# City of Burlingame

## Meeting Minutes Planning Commission

- a. 1033 Cortez Avenue, zoned R-1 - Application for Design Review for a new, two-story single-unit dwelling and detached garage and Special Permit for Side Setback for a new detached garage. (Elaine Lee, Elaine Lee Design, applicant and architect; Raymond Wong, property owner) (52 noticed) Staff Contact: 'Amelia Kolokihakaufisi

RE: 1033 Cortez Avenue New 2-story residence with new detached garage

**Tree Conflicts:**

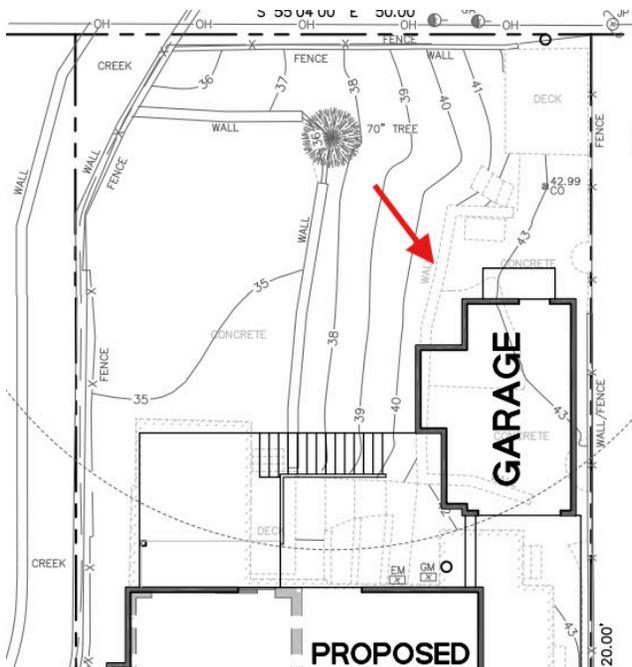
A very large, mature coast live oak tree, designated as tree #1, is situated at the rear of the property. Its overall health is good, yet significant structural and form defects are observed. The main stem is codominant at six feet, with included bark noted. This defect, where two codominant leaders (trunks) grow closely in a V-shape, can cause the leaders to break or tear, leading to severe cambium damage and making them prone to failure. This defect makes the tree more susceptible to failure during storms and heavy winds.

Several other concerns have been identified, including a 20-inch diameter limb that was removed 20 feet above grade with associated decay, poor past pruning cuts, and large heavy lateral limbs. Unfortunately, the tree has suffered from instances of poor maintenance throughout the past. Crown reduction pruning and

cabling of the codominant leaders are highly recommended to reduce the risk of limb failure. Additionally, annual inspections by a Certified Arborist are advised due to the tree's size and structural defects observed.

**Showing retaining wall to be demolished**

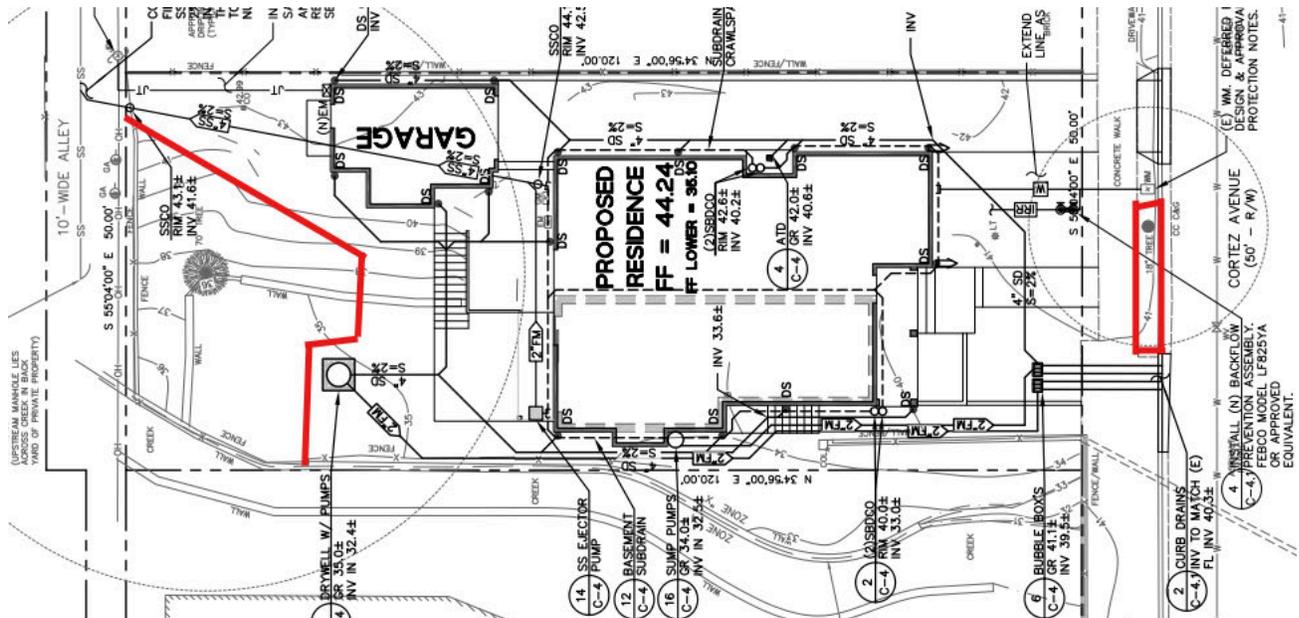
The retaining wall closest to the proposed detached garage should be demolished entirely by hand under the direct supervision of the project arborist. The demolition of the shed shall also be done entirely by hand under the direct supervision of the project arborist. Any exposed roots will need to be documented and covered in layers of wetted-down burlap. Impacts from the demolition of this retaining wall are expected to be minor to non-existent.
